# Monthly Specification Update

Intel® Server Board S5520UR

*Intel Order Number E69054-001*

**Dec 2011**

Figure 1. Removing the Heatsink

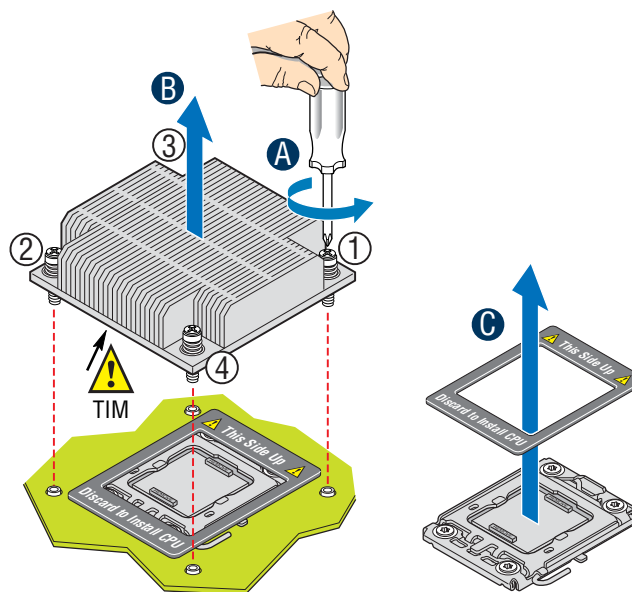
### 1. Proper Heatsink Installation and Removal Instructions are missing from Service Guide

- Problem:** The current documentation does not properly describe the installation and removal of the heatsink. Careful insertion and removal of the heatsink is required to prevent damage to the heatsink screws or backplate.
- Implication:** There is a possibility of damage to the heatsink if proper steps are not followed.
- Status:** Corrections incorporated into the latest version of the following Service Guides:
- Intel® Server System SR1600 Service Guide (Intel Order Number: E52880-003)
  - Intel® Server System SR1625 Service Guide (Intel Order Number: E52881-003)
  - Intel® Server System SR2600/SR2625 Service Guide (Intel Order Number: E51243-003)
- Workaround:** Perform the steps outlined below for installation and removal of the heatsink to avoid damage.

1. Loosen the four captive screws on the heatsink corners in a diagonal manner according to the numbers shown in figure 1 as follows:
  - Starting with the screw at location 1, loosen it by giving it **two rotations** in the anticlockwise direction and stop. (**IMPORTANT:** Do not fully loosen.)
  - Proceed to the screw at location 2 and loosen it by giving it two rotations and stop.
  - Loosen screws at locations 3 and 4 by giving each screw two rotations and then stop.
  - Repeat steps 1a through 1c by giving each screw two rotations each time until all screws are loosened.
2. Do one of the following:
  - If removing the heatsink for the first time, do the following:
    - i. Lift the heatsink from the board.
    - ii. Remove and discard the spacer (see letter "C" in figure 1).

- If a processor is already installed, do the following:
  - i. Twist the heatsink slightly to break the seal between the heatsink and the processor.
  - ii. Lift the heatsink from the processor. If it does not pull up easily, twist the heatsink again. Do not force the heatsink from the processor. Doing so could damage the processor.
